# ***Service Bulletin*** SB 2X-71-10 R1

Issued: 08 Oct 2004  
Revised: 24 May 2007

Model SR20

## **ATA 71-70: Engine Drains Oil Breather Line Insulation Sleeve Installation**

**Figure 01 - Oil Breather Line Insulation Sleeve Installation**

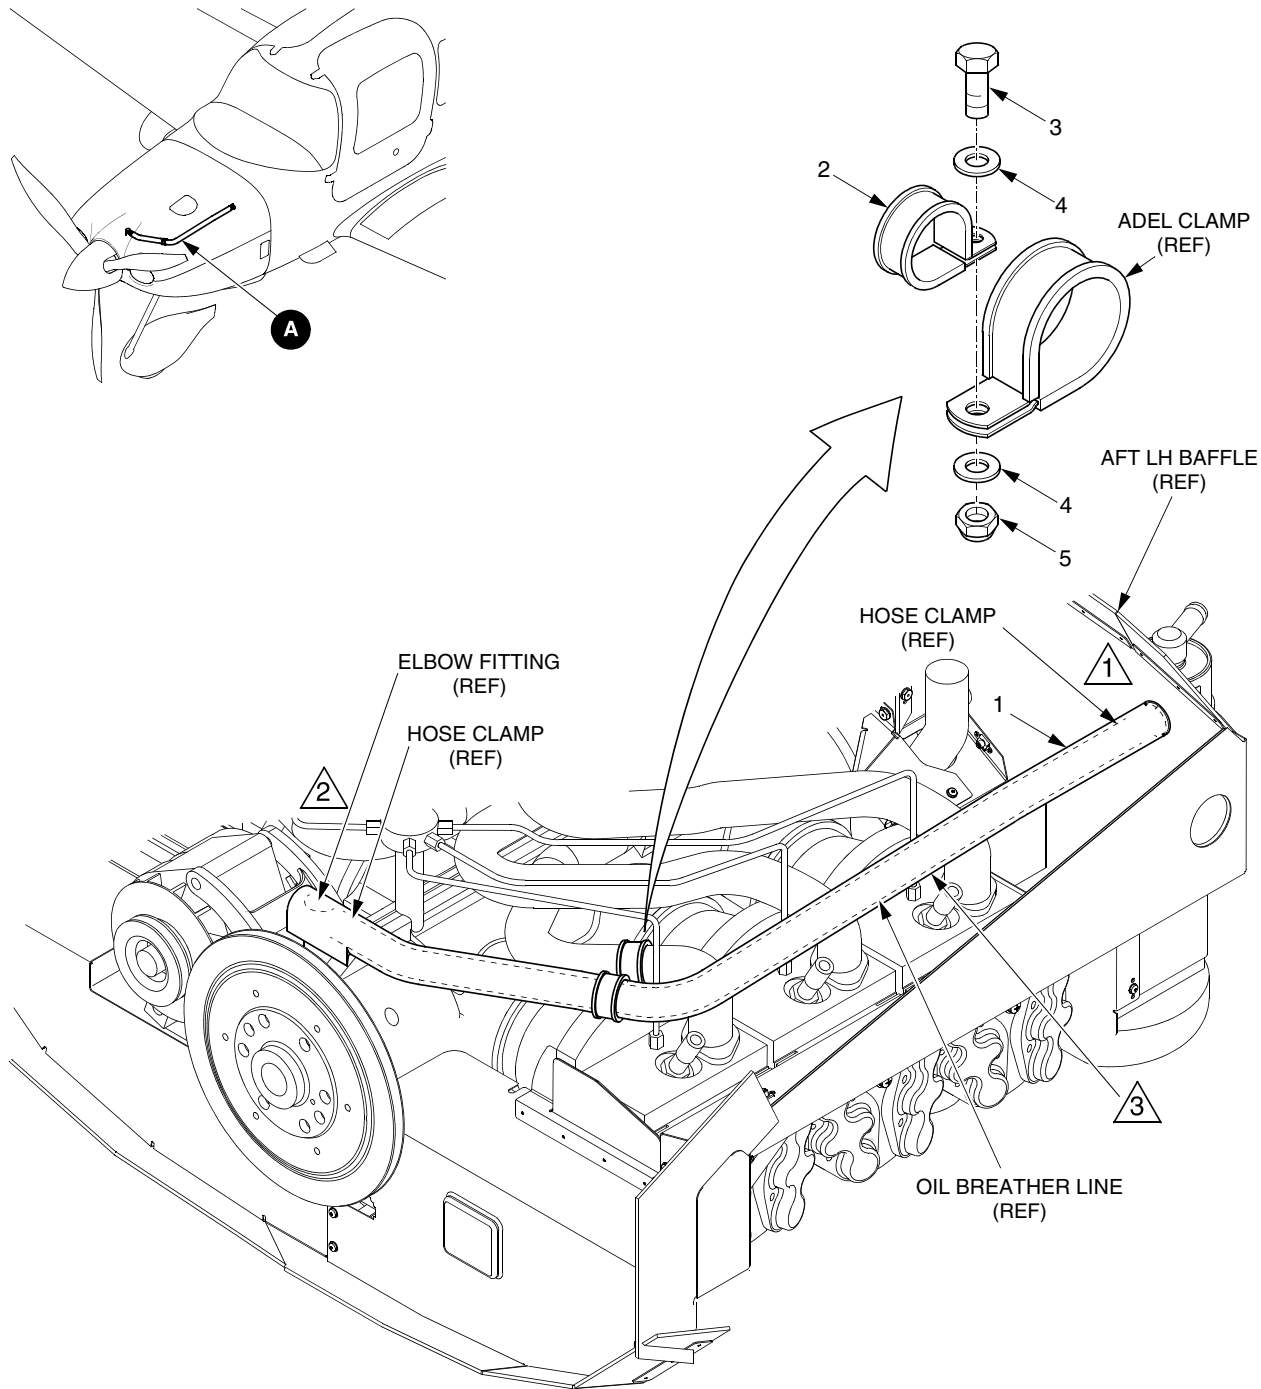
During extremely cold weather conditions, inadequate preheating of the engine may cause moisture in the oil breather line to freeze which could result in high engine oil pressure, improper engine venting, and possible loss of engine oil. To correct this condition, an insulation sleeve may be installed over the oil breather line.

Install sleeve with modified end positioned at forward end of oil breather line.

4. Slide insulation sleeve (17092-001) over oil breather line until end of insulation sleeve is  $0.5 \pm 0.5$  inch ( $1.27 \pm 1.27$  cm) from aft LH baffle.
5. Position adel clamp (MS21919WDG24) over oil breather line and insulation sleeve.
6. Install existing bolt, washer, and nut to secure adel clamp for oil breather line and insulation sleeve to existing adel clamp on engine.
7. Route oil breather line and insulation sleeve forward to elbow fitting.

**Note:** Trim aft end of insulation sleeve length if excess interferes with installation of oil breather line to elbow fitting.

Verify no low points exist in oil breather line.

8. Install and secure forward end of oil breather line to elbow fitting with existing hose clamp.
9. Slide modified end of insulation sleeve over end of oil breather line and hose clamp at elbow fitting.

- 1 Slide insulation sleeve over oil breather line until end of insulation sleeve is  $0.5 \pm 0.5$  inch ( $1.27 \pm 1.27$  cm) from aft LH baffle.
- 2 Trim end of insulation sleeve length if excess interferes with installation of oil breather line to elbow fitting.
- 3 Verify no low points exist in oil breather line.
